**From:** [Kevin O'Brien](#)  
**To:** [Plan Commission Comments](#)  
**Subject:** Zion redevelopment Agenda items 10-13  
**Date:** Monday, April 25, 2022 4:05:35 PM

Creating Section 28.022-00560 of the Madison General Ordinances to rezone property located at 2165 Linden Avenue, 15th Aldermanic District, from TR-V1 (Traditional Residential - Varied 1) District to PD(GDP) Planned Development (General Development Plan) and creating Section 28.022-00561 to approve a Specific Implementation Plan.

### **Plan Commission Meeting April 25, 2022**

Plan Commission 4/25/2022  
Agenda Item #11  
File #70655

2165 Linden, Proposed PD

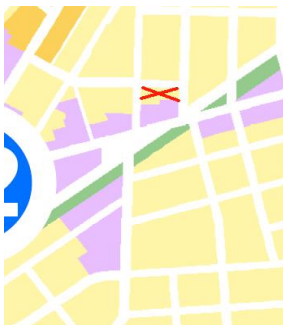
The proposed Linden PD building is comparable to the S Park TSS building.

- The height is comparable: 38' for Linden, 40' for S Park
- The length is comparable: 204' for Linden, 230' for S Park (or 13% longer than Linden)
- Setbacks are comparable: The setback from the property line along Linden is 7.58'. S Park has an 8' setback. The S Park setback is for the full length of the building. The Linden setback is only 2' for 104' of the length of the building (where the front porches encroach into the setback).
- Usable open space is comparable: Both have about  $\frac{2}{3}$  of the usable open space in balconies, both have landscaping covering much of what is claimed to be ground level usable open space.
- Lot size: Linden is .47 acres, S Park is .64 acres. (About 80% of the increased S Park lot size is devoted to a surface parking lot.)

Standards for Approval of a PD

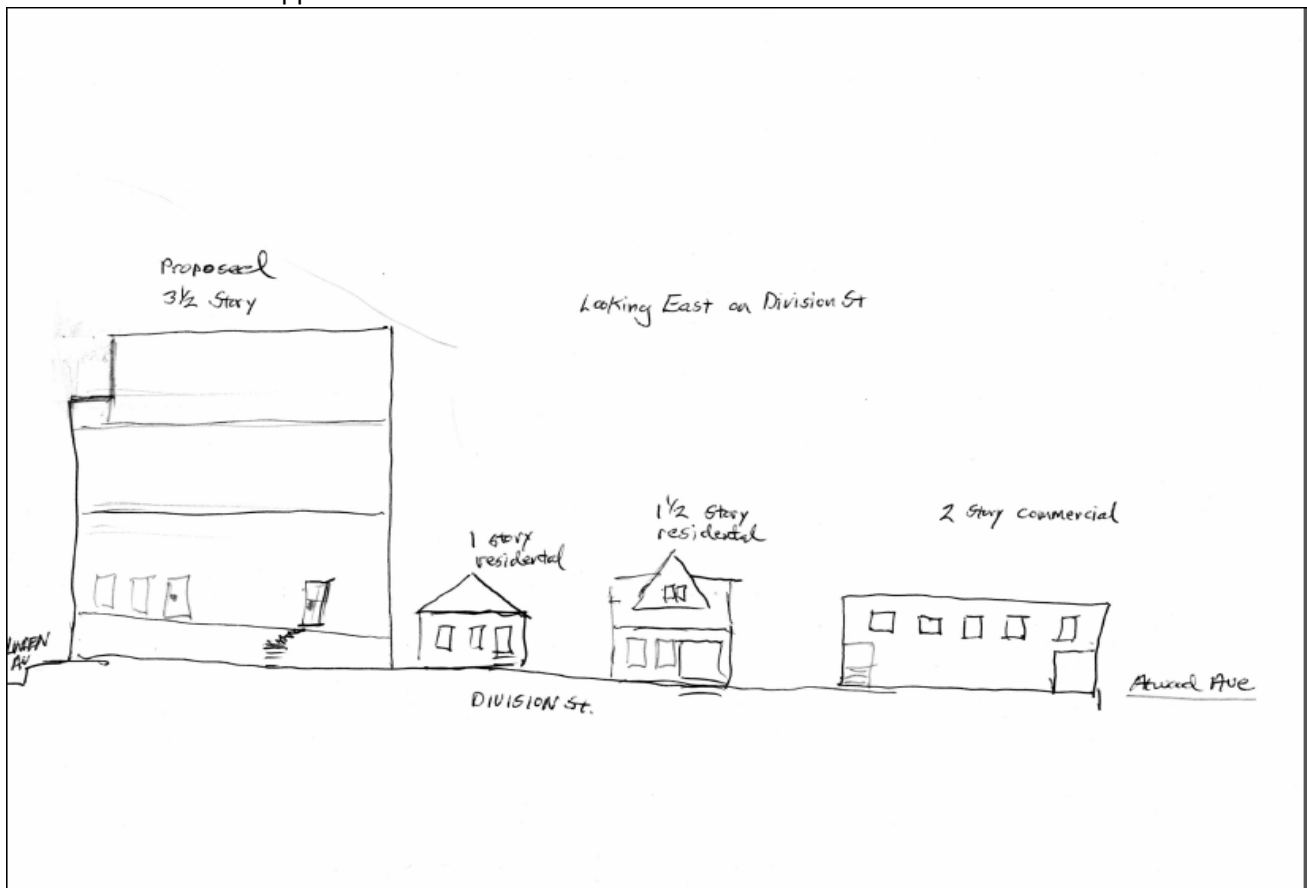
*D. Maximum Building Height: Heights shall be as indicated on the adopted plans and shall be no higher than 3 stories. Page 34 of Land Use Application*

This is not a level lot and slopes down towards Division Street. The building of 3 stories on the Division Street side is actually higher than "3 stories" relative to the other houses on Division St. There is a wall and 2 sets of stairs to enter the units on Division Street to adjust for the slope, thus making it actually higher from the street level than Dunning Street. The renderings fail to show a view from that perspective. The small one story house in the rendering is a white structure suggesting a garage or storage shed. It is therefore NOT compatible, nor transitional with the surrounding area. The only mention of transition is on the southwest side with the Cornerstone Building.
